Appendix 1-2 Initial Study/Mitigated Negative Declaration Response to Comments

May 2020 | Response to Comments on Mitigated Negative Declaration
SCH # 2020029070

DEL MAR HEIGHTS SCHOOL REBUILD PROJECT

Del Mar Union School District

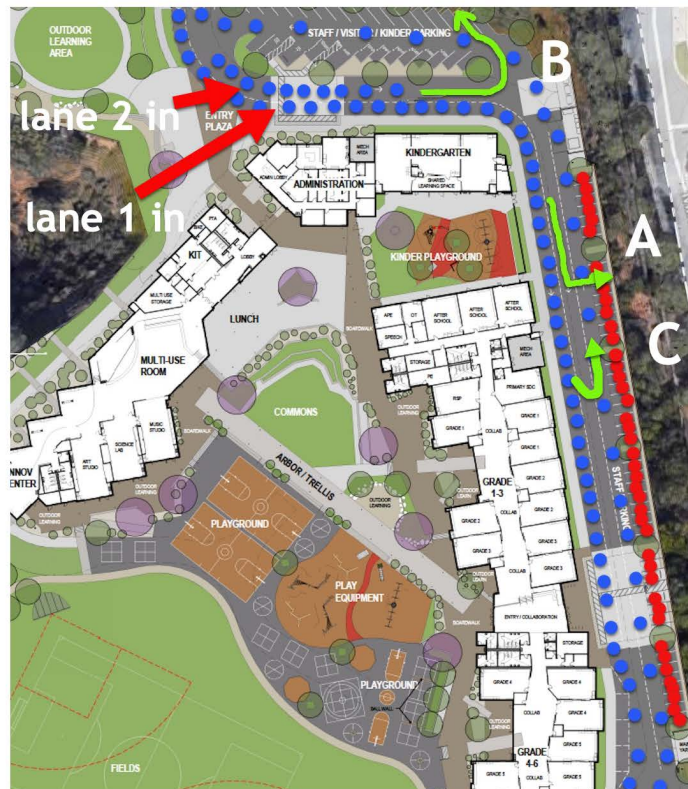
The three lane onsite queue combines emergency vehicle access, bi-directional traffic, drop-off, pick-up, merger of two lanes into one at the south turnaround, and forty-five 90° angle parking spots into a width that is seven feet narrower than Boquita Drive. Once you get in, if you follow the rules, you are stuck until you go all the way to the south roundabout and make your way back. Every one of the forty-five staff parking spots pulls out into the single outbound lane of the queue. If you want to park in one of the staff spots, you must wait until you get to the turnaround and head back north - assuming you follow the rules rather than just cut across traffic and grab an open spot.

Current school design

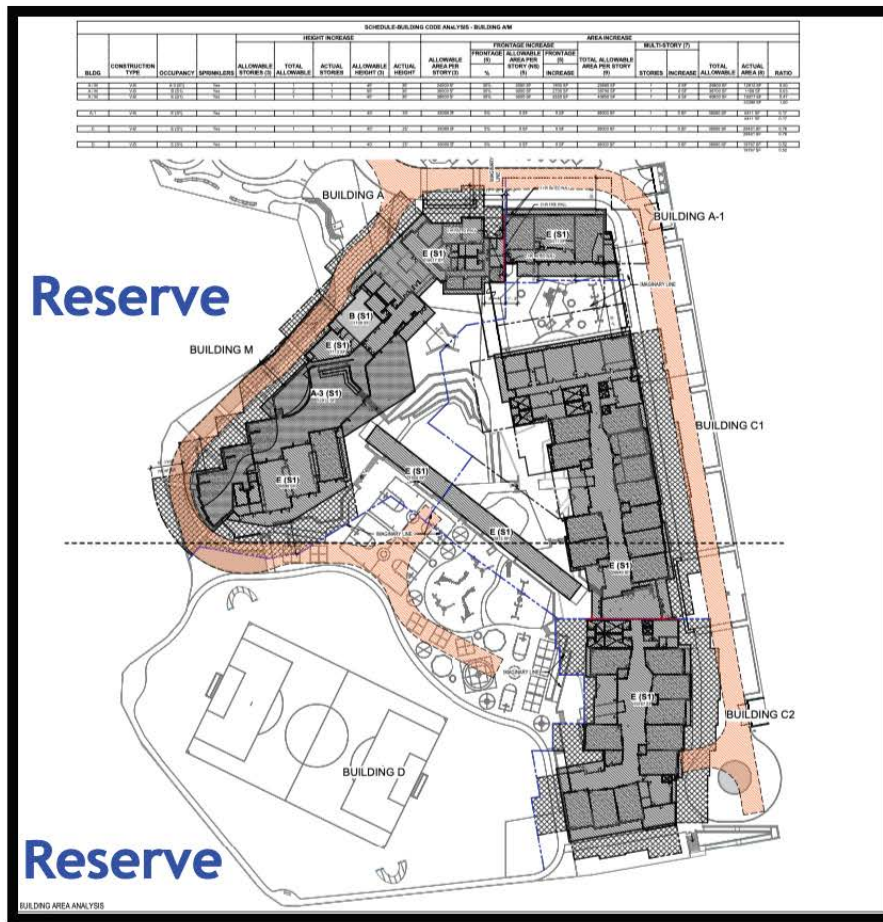
In the photo above, you can see the path a fire truck takes to gain site access today. Entry on Boquita, turn east and then move across the blacktop to the west - full site access and within 150' of every inch of every building, as required for non-sprinklered buildings.

- JJ-146 The Board of Education will consider all comments in its deliberations concerning the project.
- J-147 See responses to J-98 and J-120.
- J-148-154 The existing fire access lane is inadequate as the width of the lane is only 10 feet between the edge of the slope and the building. The minimum width is 20 feet per the 2019 California Fire Code. The proposed fire lane is 20 feet in width throughout its length and it eliminates the existing restricted access point (see Figure 7, *Fire Access Lane*). The fire lane includes hammerhead turnarounds and the hose length distances are in compliance with the 2019 California Fire Code. Further, the plan has been reviewed and pre-approved by the City of San Diego Fire Marshall.

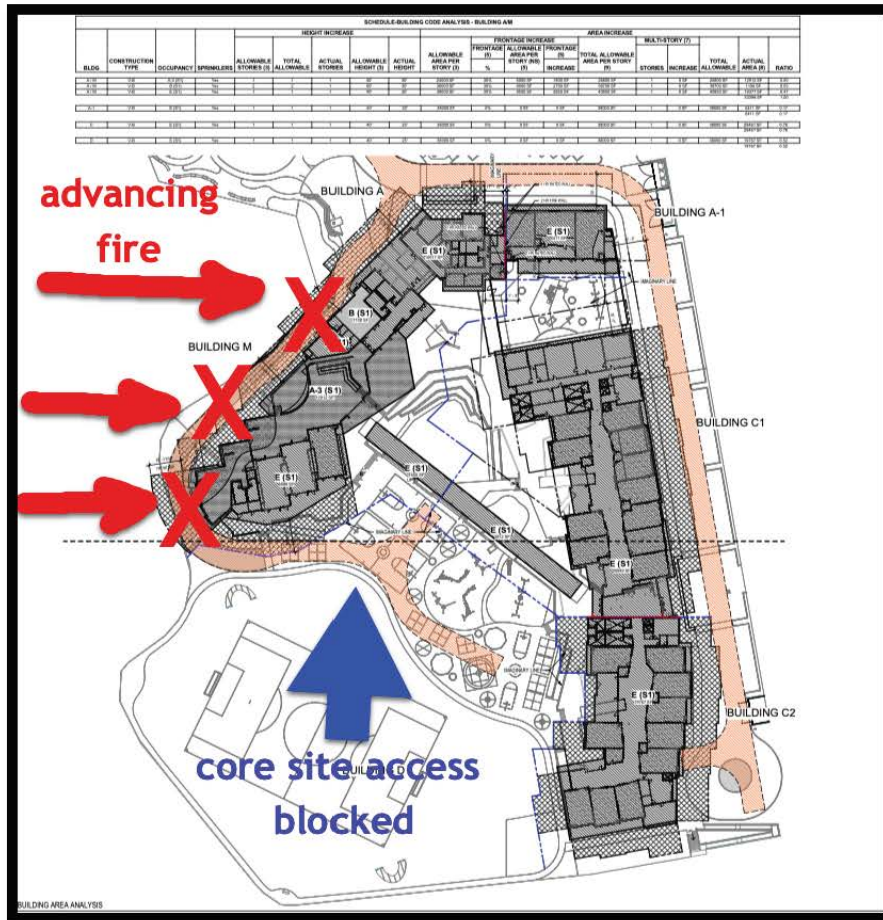
But suppose there is an Reserve Extension fire that is hot on the rim of the canyon on the west of the school site, or has already advanced onto the west buildings. As shown in earlier sections, conditions and topology make that more than a theoretical possibility.

Figure 2.

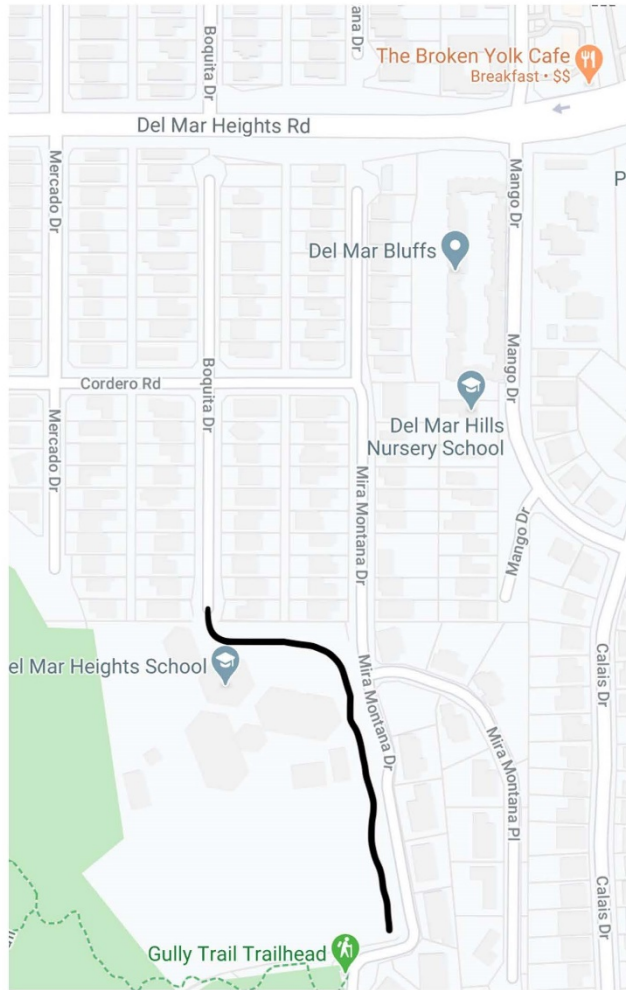
A map of the area is provided in Figure 2, below. Del Mar Heights Road, Mercado, Cordero and Boquita are indicated, as is the current entrance to the school. The avenue of the Proposed Remodel is roughly drawn in black. The avenue is seen to parallel Mira Montana to its east. | U-16
